South Texas Project Electric Generating Station P.O. Box 282 Wadsworth, Texas 77483

September 21, 2009
U7-C-STP-NRC-090146

South Texas Project
Units 3 and 4
Docket Nos. 52-012 and 52-013
Responses to Requests for Additional Information

Attached are responses to NRC staff questions in Request for Additional Information (RAI) letter number 202, related to COLA Part 2, Tier 2, Sections 2.4S.12, "Groundwater," 2.5S.2, "Vibratory Ground Motion," and 2.5S.4, "Stability of Subsurface Materials and Foundations."

Figure 2.5S.2-2 Dames and Moore EPRI Source Zones

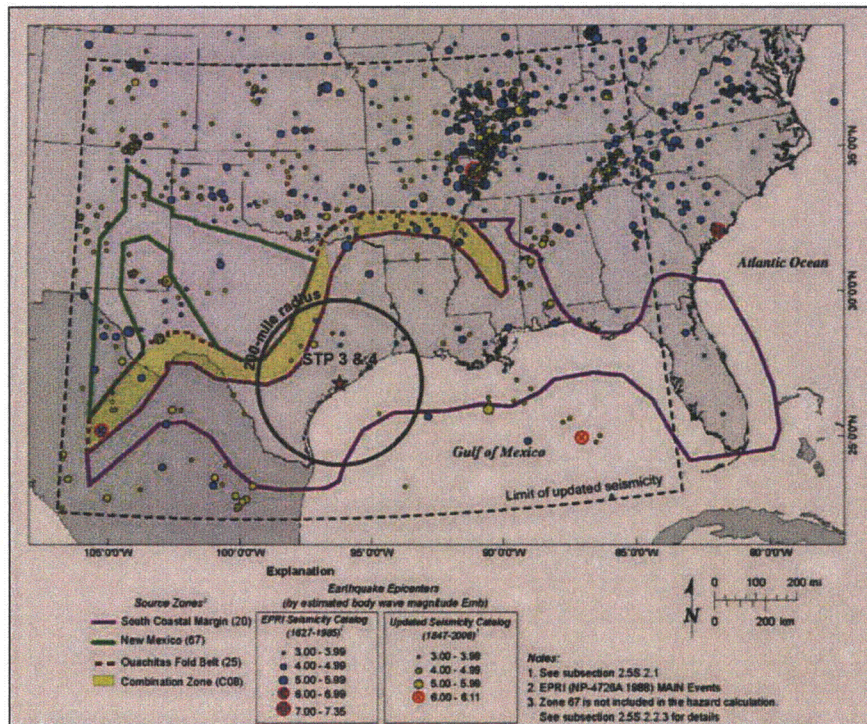
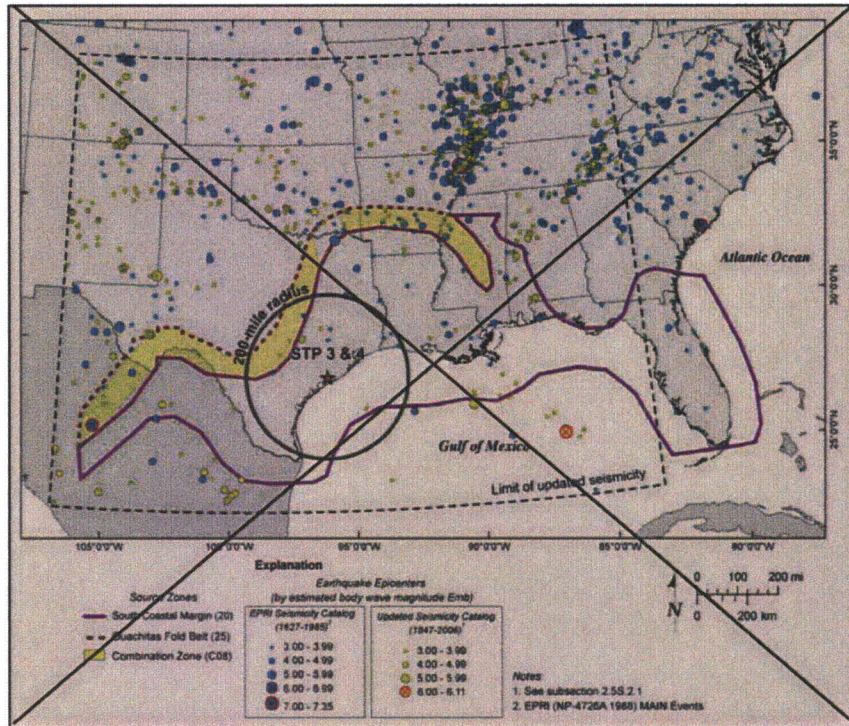
Based on Section 2.5S.2, the EPRI SOG ESTs either assigned low maximum magnitudes and low probabilities of activities or provided no source coverage to the area located in the northwest corner of the site region (see FSAR Figure 2.5.2-8). With the result that the hazard contribution from this area is less than or equal to 1%. Please justify this lack of coverage and whether the EPRI SOG source models adequately characterize the hazard surrounding the site.

FSAR Figure 2.5S.2-8 is a composite map of all EPRI SOG seismic sources that specifically cover the Gulf of Mexico. FSAR Figures 2.5S.2-1 through 2.5S.2-6 are maps of the EPRI SOG seismic sources from each of the Earth Science Teams [EST] that contribute to 99% of the seismic hazard, including seismic sources that cover the northwest corner of the site region not shown in Figure 2.5S.2-8. Tables 2.5S.2-7 through 2.5S.2-12 list all EPRI SOG seismic sources from the ESTs that are located within 200 miles of the site region, including three sources not contributing to 99% of the seismic hazard, and, therefore, not mapped in the FSAR figures of EST seismic sources.

In response to this RAI, the three non-contributing seismic sources listed in Tables 2.5S.2-7 through 2.5S.2-12 that are not already plotted in Figures 2.5S.2-1 through 2.5S.2-6 -- Dames and Moore seismic source 67, Rondout seismic source C02, and Weston Geophysical Corporation seismic source C31 – are now plotted in their respective FSAR Figures 2.5S.2-2, 2.5S.2-4, and 2.5S.2-5. The revised COLA figures are included with this RAI response.

Figure 2.5S.4-57 Deep Shear Wave Velocity Profile for the STP Site

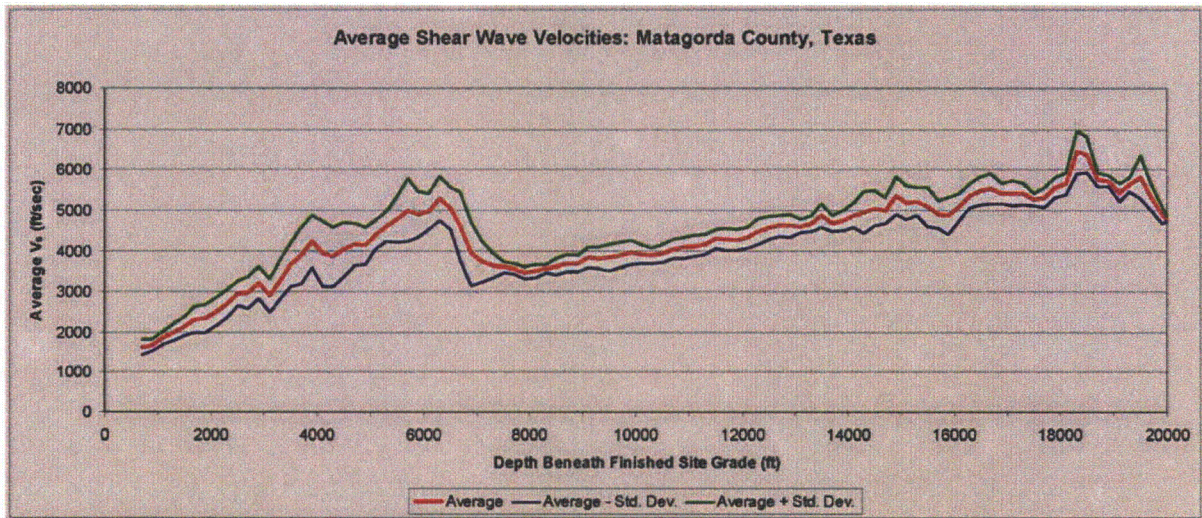
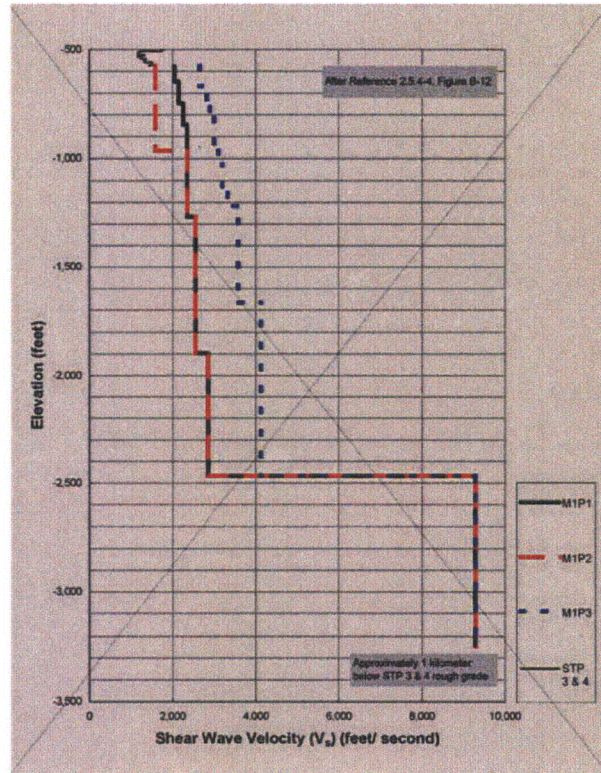
In Section 2.5S.2.5, you mentioned that $V_s = 9200$ fps “is located at more than 30,000 ft (9144 m) below the ground surface.” However, Figure 2.5.4-57 in Section 2.5S.4 indicates that below 2500 ft, the V_s is about 9200 ft/s, and in the FSAR Com 2.5 S-1, you also indicated that “below 2500 ft depth, a hard rock shear wave velocity of 9285 ft/s was assumed.” Please clarify this discrepancy.

The statement in STP COLA Section 2.5S.2.5 describes the natural geologic condition. For the purpose of the STP site response analysis, the soil column profile is truncated at a depth of 8100 ft. The soil column truncation depth is selected to capture the seismic response for frequencies greater than or equal to 0.1 Hz. Below 8100 ft, bedrock is assumed with a shear wave velocity of 9200 ft/s and the UHS rock motion is applied at bedrock horizon. Further discussion of the selection of the soil profile for the STP site response analysis is presented in Section 2.5S.2.5 of STP COLA Rev. 3, which is planned to be submitted to the NRC in September 2009. To reflect the shear wave velocity derived from the deep sonic log data, Figure 2.5S.4-57 will be replaced in a future COLA revision, as shown below.

The following statement is included in the response to FSAR Com 2.5S-1 (Reference 1), “Previously, shear wave velocities below 600 feet depth were based on the more generic “Mississippi embayment lowlands profile” down to 2,500 feet depth. Below 2,500 feet depth, a hard rock shear wave velocity of 9,285 feet/second was assumed.” However, as discussed in Reference 1, the above approach has been modified and an updated soil profile has been used in the analysis, as described in Section 2.5S.2.5 and shown in Figure 2.5S.2-35a in STP COLA Rev. 3. A copy of Figure 2.5S.2-35a from STP COLA Rev. 3 is included in this RAI response.
